SERVICE BULLETIN: JSB 031-2

Subject: Jabiru Engine Through Bolts

Affected Models: Jabiru 2200 and 3300 Engines

SAFETY DIRECTIVE: JSD 031-2

Figure 1 – General Engine Layout

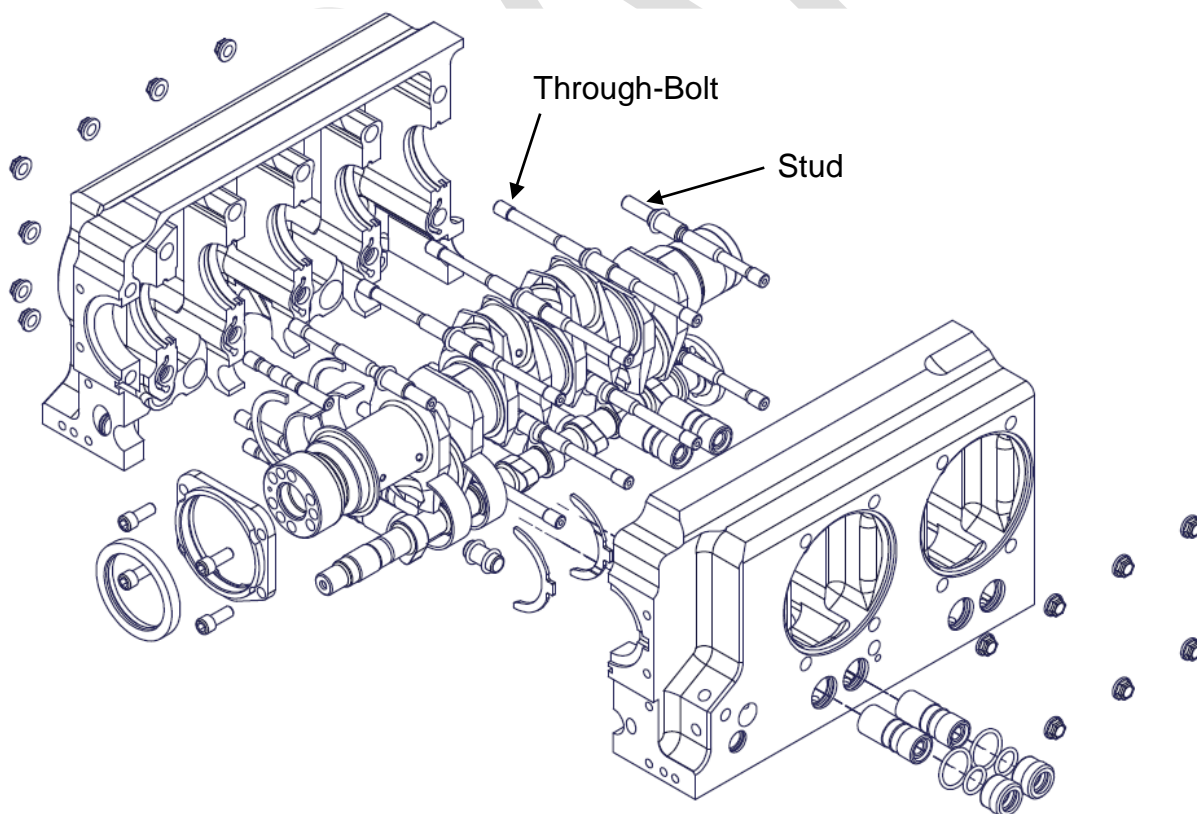
- Jabiru Engines are assembled using a combination of Through-Bolts and Studs – as shown in Figure 1 below. The number of through-bolts varies depending on which engine model is considered but there are always 6 studs (not all with the same part number). The through-bolts and studs hold the cylinders in place and the halves of the crankcases together.

- There have been some cases of these bolts failing in service, leading to engine failure.
- In April 2011 JSB031 Issue 1 was issued. This bulletin detailed then-current inspections and alterations required to correct this potential unsafe condition with the through-bolt hardware of certain Jabiru 2200 and 3300 engines.

- The following is required at the interval given in Section 4.1.
 - a) The existing MS21042 style nuts must be replaced.
 - b) New through-bolts and studs must be fitted. **Note that replacing studs requires that the cases be split: the scope of work is generally equivalent to an engine bulk strip.**

- c) Cylinders must be removed, cleaned and thoroughly inspected for cracks by trained personnel using a bright light and minimum 10x magnifying glass in the region between the lower cylinder flange and the first full cylinder fin. Dye Penetrant or Magnetic Particle Inspections are also acceptable. Where no cracks are found the part may be re-fitted.

- The updated engine configuration must match an approved configuration as detailed in the current Jabiru Engine Overhaul Manual, Document JEM0001 Issue 4 (or later approved issue). An MS21042 Style nut is shown in Figure 2 for identification purposes.
